Development at Firhouse Inn

ABP SHD Statement of Response

Firhouse Road, Dublin 24

Proposed Mount Carmel Park Elevation

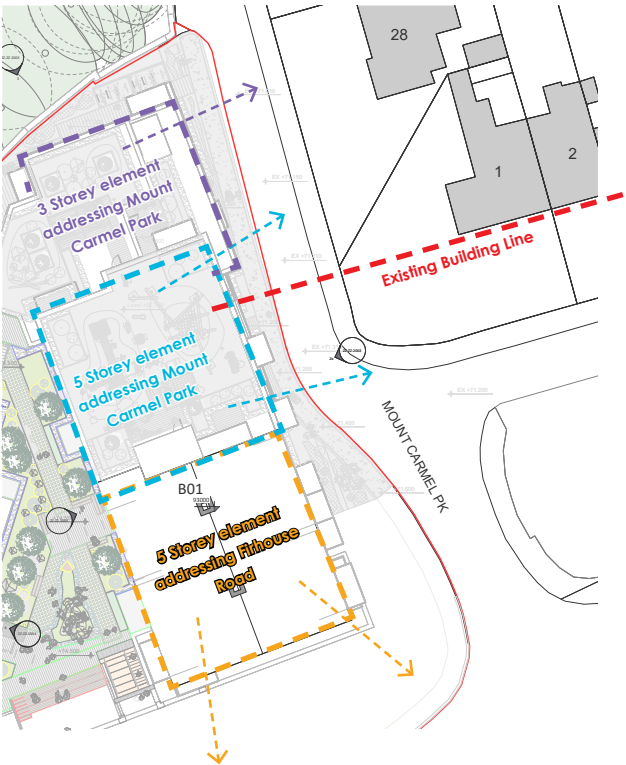
The proposed development has a height of 4-5 storeys above basement/ undercroft and contravenes the County Development Plan requirement for development of more than 2 storeys to be located 35m away from existing low-rise development. The Planning Authority supports 3-5 storey development here in principle, but considers that the transition in height to the north-east should be gentler, i.e. the step down to Mount Carmel park should be to a height of 3 storeys above the ground there, and the step up to 5 storeys (perceived as 6 at that location) should be gentler.

3.3.3 Massing Along Mount Carmel Park

Block 01 forms the new boundary along Mount Carmel Park.

Partial Proposed Site Layout Plan showing entrance points to perimeter space, and pinch points

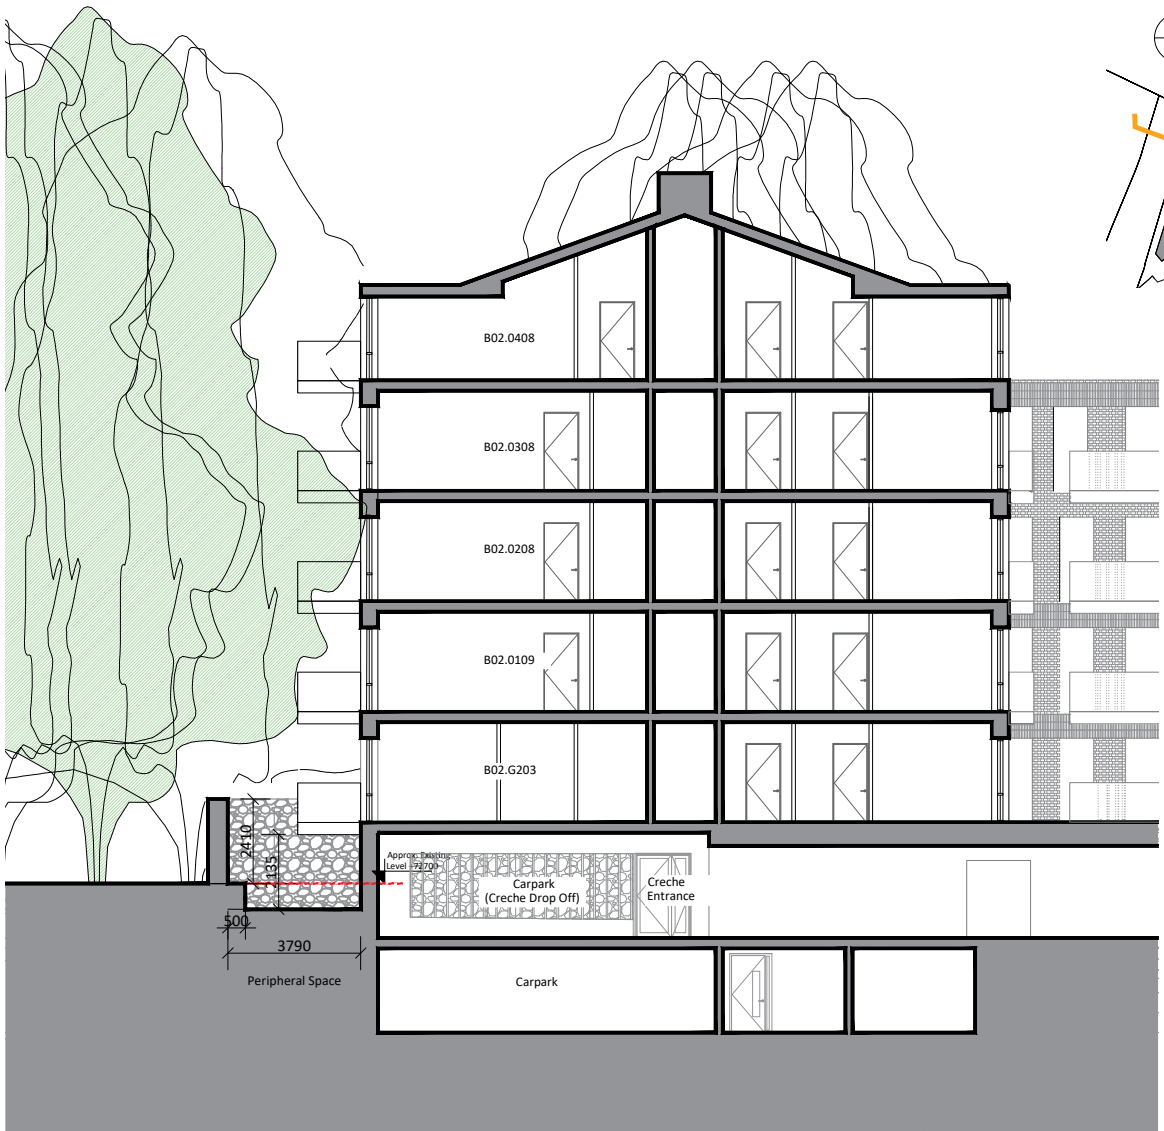
It may be preferable to improve the proposed layout by: Increasing separation distance to the N and NW boundary; Relocation and reconfiguration of commercial units to provide these uses on ground level, and to address the public open space along the long edge with Block A and the podium access; Increasing the ratio of such units to residential; Increase number of dual aspect units; and Providing own-door units on Mount Carmel Park. In general, we would like to see potential alternative layouts and the rationale for the selection of the final approach, or the discounting of other approaches. The applicant should address the issue of the roof terrace to the north-east and its relationship with housing there. The roof terrace may need to be taken in from the roof edge at this location.

There is direct access into this perimeter space at four locations:

1. From the south-western corner.
2. Directly from the vehicle access route to the carpark.
3. Through the creche dropoff gate within the carpark and through the creche play-area.
4. From the north-eastern corner.

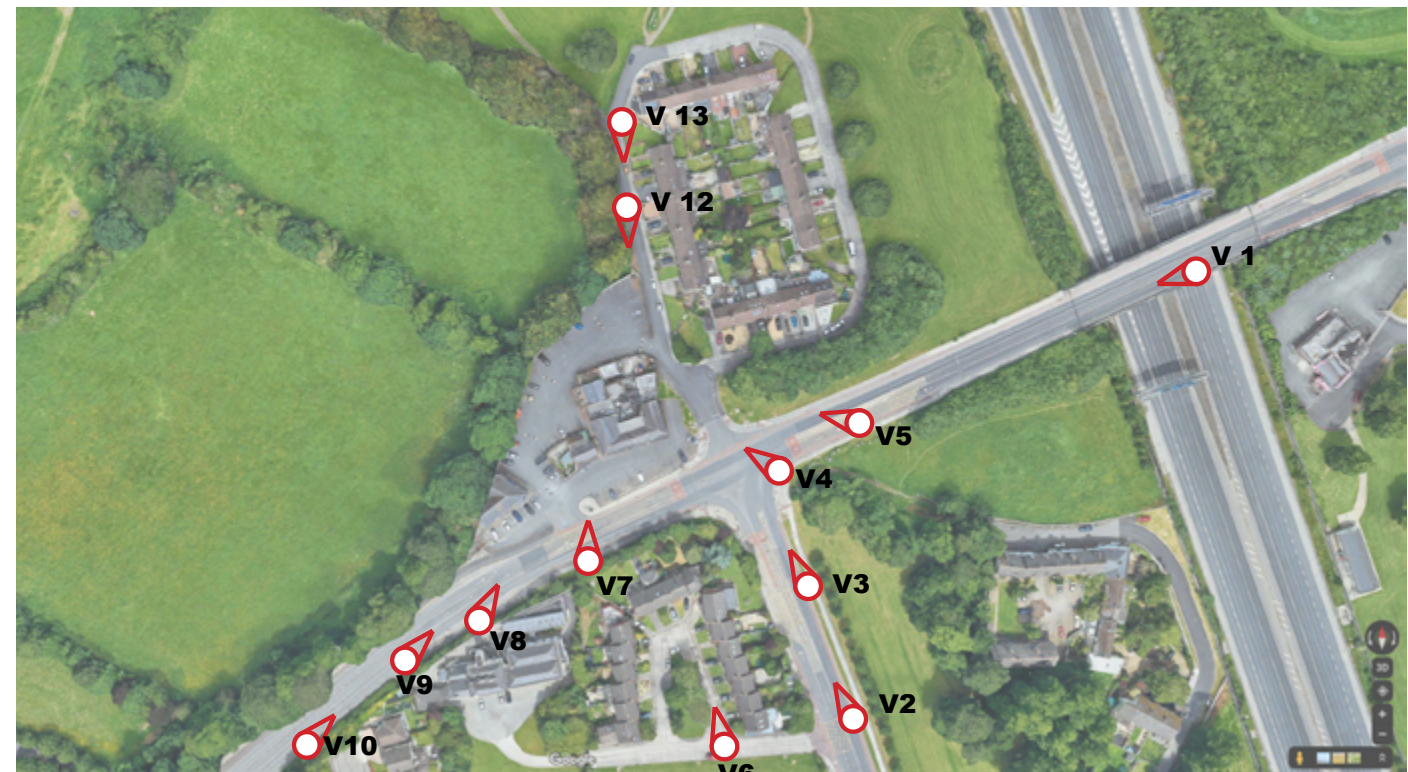
There are protected views into the Dodder Valley from the north (as per County Development Plan maps). The applicant should provide photomontage/CGI images from this location. The other sensitive location is Mount Carmel Park and images should be provided of views from here. Views at street level should be provided to allow a fuller visual assessment of the scheme.
